ANALYSIS

This ordinance repeals those provisions of Title 30 – Residential Code – of the Los Angeles County Code that incorporated by reference portions of the 2022 Edition of the California Residential Code, and the ordinance replaces them with provisions incorporating by reference portions of the 2025 California Residential Code, published by the California Building Standards Commission, with certain changes and modifications.

SECTION 3. Section R301.1.3.2 is hereby amended to read as follows:

**FIGURE R403.1.5
STEPPED FOOTING**

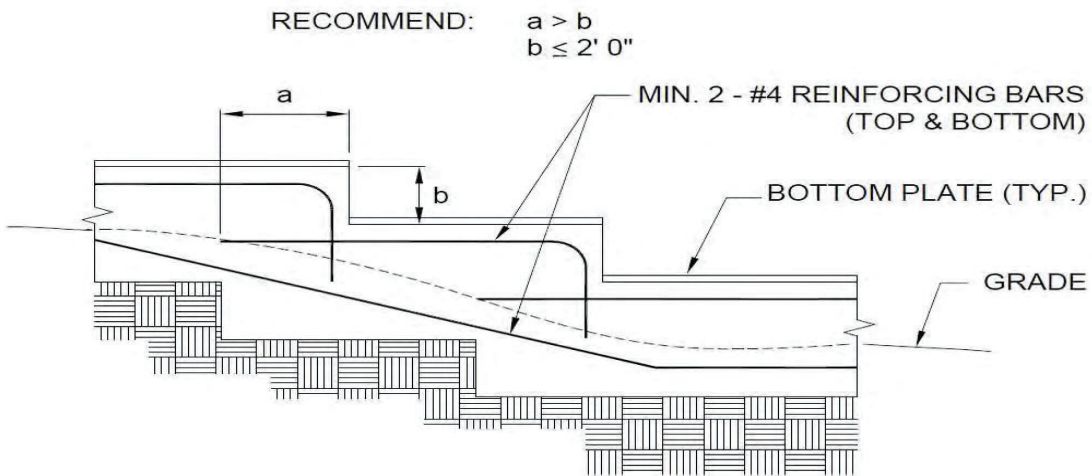
For structures located in Seismic Design Category D₀, D₁, or D₂, stepped footings shall be reinforced with two No. 4 reinforcing bars. Two bars shall be located at the top and bottom of the footings as shown in Figure R403.1.5.

SECTION 21. Figure R403.1.5 is hereby added to read as follows:

R403.1.2 R403.1.3.6 R403.1.5 Figure R403.1.5	Climatic Geological	Los Angeles County is prone to seismic activity due to the existence of active faults in the Southern California area. These amendments require minimum reinforcement in continuous footings and stepped footings to address the problem of poor performance of plain or under-reinforced footings during a seismic event. These amendments implement the recommendations of SEAOSC and the Los Angeles City Joint Task Force resulting from their investigation of the 1994 Northridge Earthquake. Interior walls can easily be called upon to resist over half of the seismic loading imposed on simple buildings or structures. Without a continuous foundation to support the braced wall line, seismic

FIGURE R503.2.4

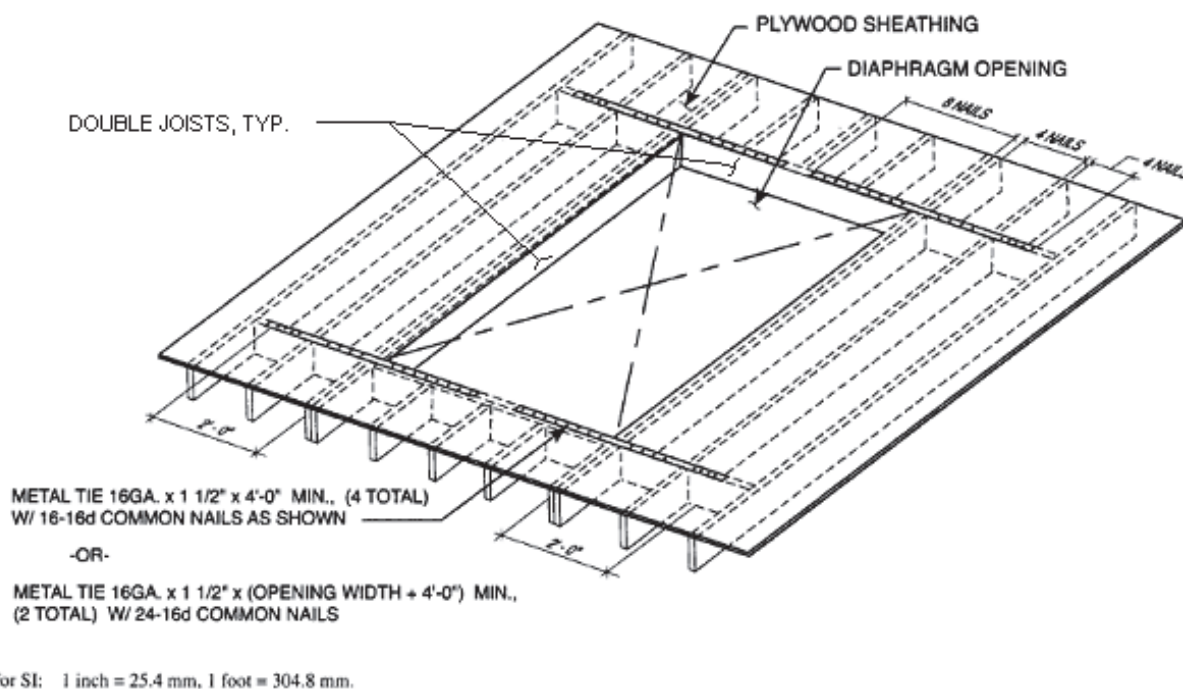
Openings in horizontal diaphragms with a dimension perpendicular to the joist that is greater than 4 feet (1.2 m) shall be constructed in accordance with Figure R503.2.4.

SECTION 25. Figure R503.2.4 is hereby added to read as follows:

- a. Blockings shall be provided beyond headers.
- b. Metal ties not less than 0.058 inch [1.47 mm (16 galvanized gage)] by 1.5 inches (38 mm) wide with eight 16d common nails on each side of the header-joist intersection. The metal ties shall have a minimum yield of 33,000 psi (227 MPa).
- c. Openings in diaphragms shall be further limited in accordance with Section R301.2.2.6.

Code Section	Condition	Explanation of Amendment
R503.2.4 Figure R503.2.4	Geological	Section R502.10 of the Code does not provide any prescriptive criteria to limit the maximum floor opening size, nor does Section R503 provide any details to address the issue of shear transfer near larger floor openings. With the higher seismic demand placed on buildings and structures in this region, it is important to ensure that a complete load path is provided to reduce or eliminate potential damage caused by seismic forces. Requiring blocking with metal ties around larger floor openings and limiting opening size is consistent with the requirements of Section R301.2.2.6.
Table R602.3(1) Table R602.3(2)	Geological	Los Angeles County is prone to seismic activity due to the existence of active faults in the Southern California area. In September 2007, limited cyclic testing data was provided to the ICC Los Angeles Chapter Structural Code Committee showing that stapled wood structural shear panels do not exhibit the same behavior as the nailed wood structural shear panels. The test results of the stapled wood structural shear panels demonstrated lower strength and drift than the nailed wood structural shear panel test results. Therefore, the use of staples as fasteners for shear walls sheathed with other materials shall not be permitted without being substantiated by cyclic testing.

FIGURE R602.10.6.1
METHOD ABW—ALTERNATE BRACED WALL PANEL

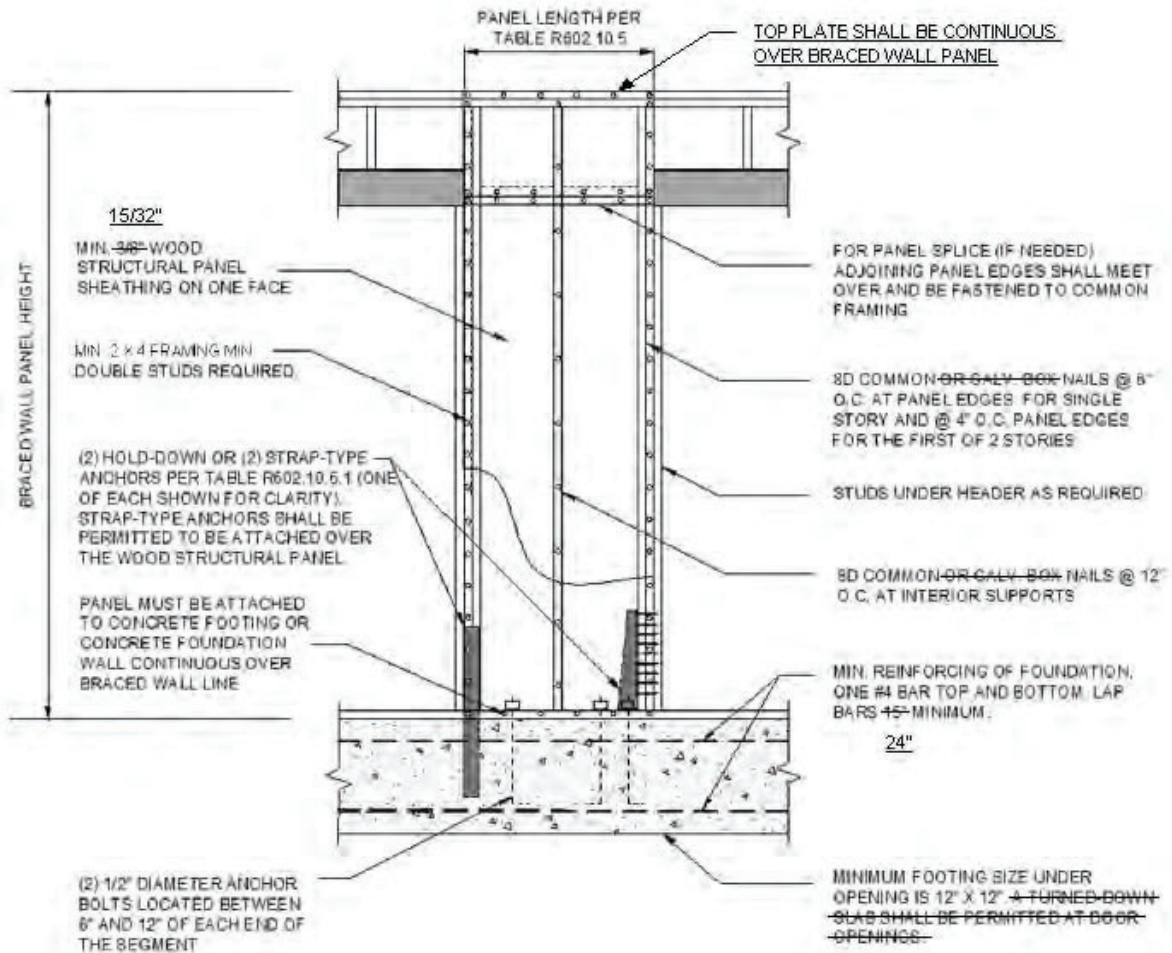
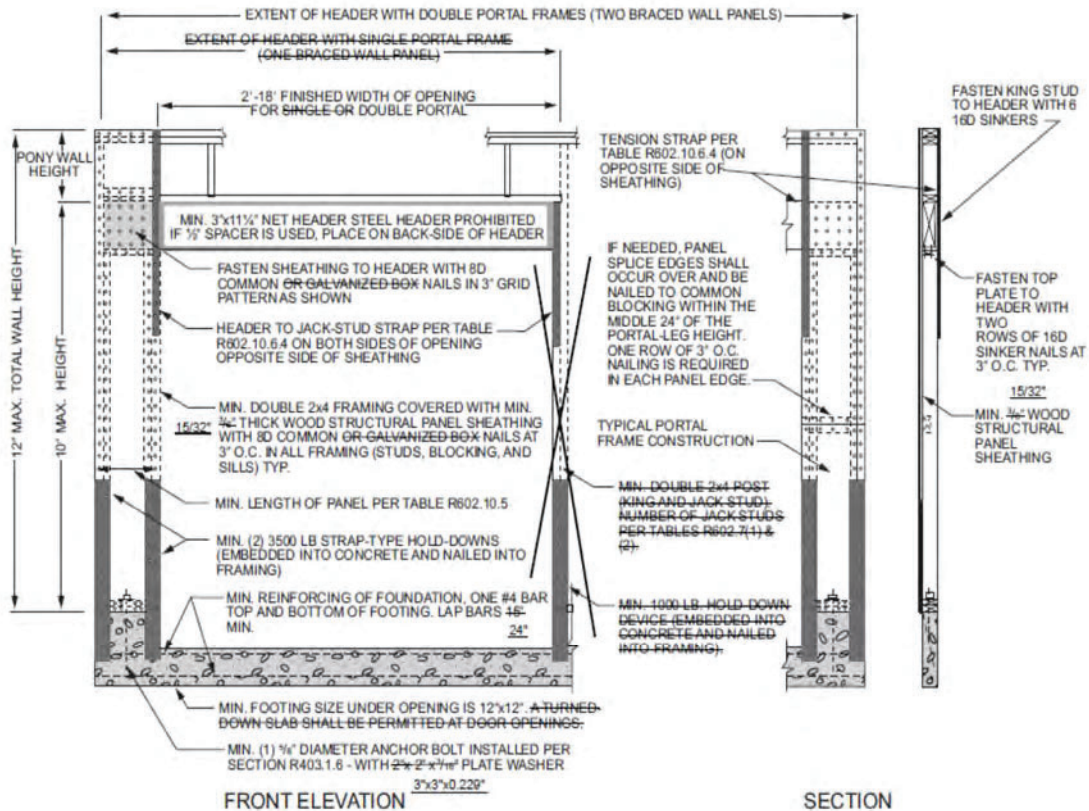
SECTION 34. Figure R602.10.6.1 is amended to read as follows:

Figure R602.10.6.1	Geological	3/8" thick 3 ply-plywood shear walls experienced many failures during the Northridge Earthquake. The poor performance of shear walls in the 1994 Northridge Earthquake was investigated by SEAOSC and the Los Angeles City Joint Task Force. Box nails were observed to cause massive and multiple failures of the typical 3/8" thick 3 ply-plywood during the Northridge Earthquake. The County of Los Angeles and cities in this region have taken extra measures to maintain the structural integrity of the framing of the shear walls when designed for high levels of seismic loads. The performance of modern day braced wall panel construction is directly related to an adequate load path extending from the roof diaphragm to the foundation system.
Figure R602.10.6.2	Geological	3/8" thick 3 ply-plywood shear walls experienced many failures during the Northridge Earthquake. The poor performance of such shear walls in the 1994 Northridge Earthquake was investigated by SEAOSC and the Los Angeles City Joint Task Force. The County of Los Angeles and cities in this region have taken extra measures to maintain the structural

Code Section	Condition	Explanation of Amendment
		integrity of the framing of the shear walls when designed for high levels of seismic loads. Box nails were observed to cause massive and multiple failures of typical 3/8-inch thick plywood during the Northridge Earthquake. This change to the minimum lap splice requirement is consistent with Section 25.5 of ACI 318-19.
Figure R602.10.6.4	Geological	3/8" thick 3 ply-plywood shear walls experienced many failures during the Northridge Earthquake. The poor performance of such shear walls in the 1994 Northridge Earthquake was investigated by SEAOSC and the Los Angeles City Joint Task Force. The County of Los Angeles and cities in this region have taken extra measures to maintain the structural integrity of the framing of the shear walls when designed for high levels of seismic loads. The proposal in which "washers shall be a minimum of 0.229 inch by 3 inches by 3 inches in size" is consistent with Section R602.11.1 of the California Residential Code and Section 2308.7.1 of the California Building Code.

FIGURE R602.10.6.2
METHOD PFH—PORTAL FRAME WITH HOLD-DOWNS
AT DETACHED GARAGE DOOR OPENINGS

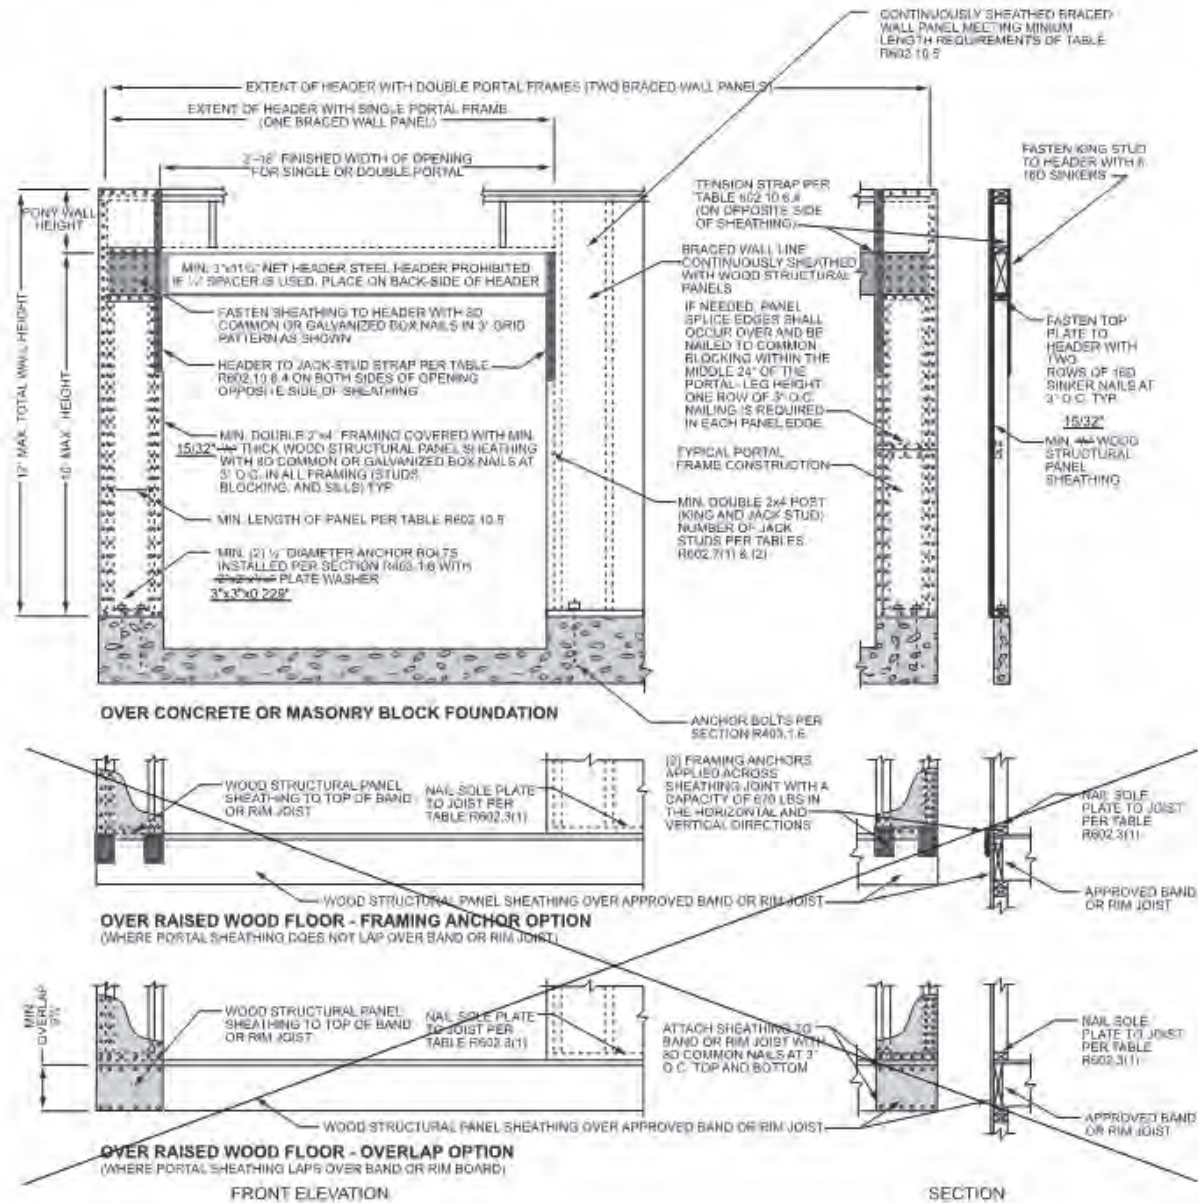
SECTION 35. Figure R602.10.6.2 is hereby amended to read as follows:
